UNITED STATES PATENT AND TRADEMARK OFFICE

APPLICATION NO.	FILING DATE	FIRST NAMED INVENTOR	ATTORNEY DOCKET NO.	CONFIRMATION NO.
09/919,699	07/31/2001	Donald J. Milligan	10006051-1	5384

Office Action Summary

DETAILED ACTION

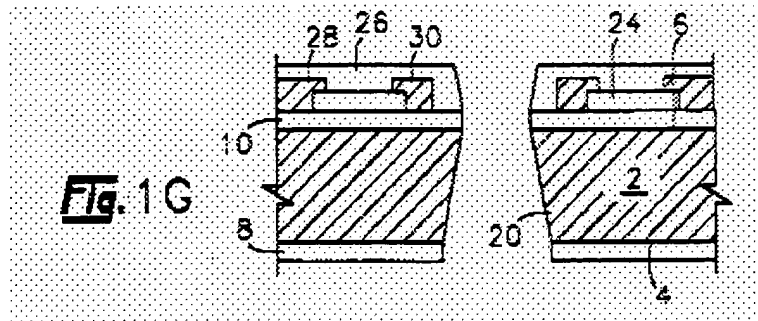
1. Claims 15-20, 28-30 are rejected under 35 U.S.C. 103(a) as being unpatentable over Murthy et al. (US 5658471) in view of Mantell et al. (US 5867192).

Murthy et al. disclose a fluid ejecting device comprising:

a silicon substrate having <100> crystalline orientation (FIG. 1G, element 2, and column 1, line 44-45),

a plurality of fluid/ink drop generators (FIG. 1G) formed on a first surface of said silicon substrate,

a fluid/ink feed slot extending from a second surface of said silicon substrate to said first surface (FIG. 1G, element 20) having an opening at the first surface having a width W1 (FIG. 4B, element 48) that is less than a width W2 (FIG. 4B, element 46) of an opening at the second surface.

Referring to claims 16, 19: wherein W1 is about 100 micrometers or less (column 8, line 45-50).

Referring to claims 17, 20: wherein W2 is about 300 micrometers or less (column 8, line 45-50).

Murthy et al. do not disclose that said fluid slot formed by deep reactive ion etching followed by anisotropic wet etching.

However, Mantel et al. disclose a process of making cavities in a silicon substrate having <100> crystalline orientation wherein the cavities are formed by deep reactive ion etching process followed by anisotropic wet etching process (column 3, line 43 to column 4, line 23).

Therefore, it would have been obvious for one having ordinary skill in the art at the time the invention was made to form the ink feed slots in the printhead disclosed by Murthy et al. by the process of the deep reactive ion etching followed by anisotropic wet etching as disclosed Mantell et al. The motivation of doing so is that the advantage of the reactive ion etching is easily reproducible and the wet etching process is self-terminating, this is convenient for mass production as taught by Mantell et al. (column 3, line 46-48 and column 4, line 5-10).

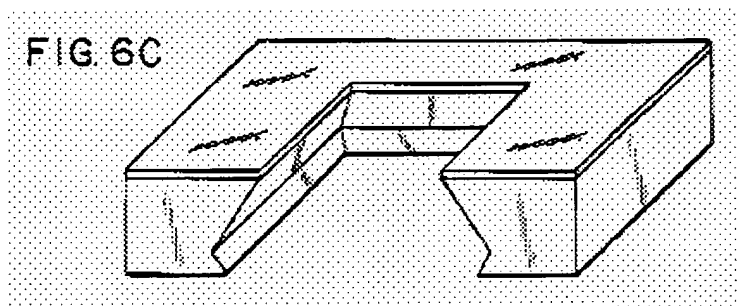
2. Claims 21-27 are rejected under 35 U.S.C. 103(a) as being unpatentable over Murthy et al. (US 5658471) in view of Mantell et al. (US 5867192) and further in view of Yagi et al. (US 6143190).

Murthy et al. and Mantell et al. disclose the claimed invention as discussed above, except wherein the fluid feed slot has a diamond shape (**referring to claims 21, 24**), the fluid feed slot

has a width at a location intermediate the first surface and the second surface which is larger than width W1 (**referring to claims 22, 25, 27**), and wherein a longitudinal extent of the fluid feed slot is aligned with a $\langle 100 \rangle$ plane of the substrate (**Referring to claims 23 and 26**).

Yagi et al. disclose a fluid feed slot (in term of “a through-hole serving as an ink supplying hole” (column 27, line 4-6) in a $\langle 100 \rangle$ silicon wafer (column 12, line 33-34) has a diamond shape (FIG. 6C) with a width at a location intermediate the first surface and the second surface which is larger than width W1 (FIG. 6C), and wherein a longitudinal extent of the fluid feed slot is aligned with a $\langle 100 \rangle$ plane of the substrate (FIG. 6C).

Therefore, it would have been obvious for one having ordinary skill in the art at the time the invention was made to shape the ink feed slots in the printhead disclosed by Murthy et al. in view of Mantell et al. as a diamond having a width at a location intermediate the first surface and the second surface larger than width W1 as disclosed by Yagi et al. The motivation of doing so is to gain the controlling of the fluid conductance to a desired value, which could not be achieved by the conventional technique, as taught by Yagi et al. (column 12, line 20-28).
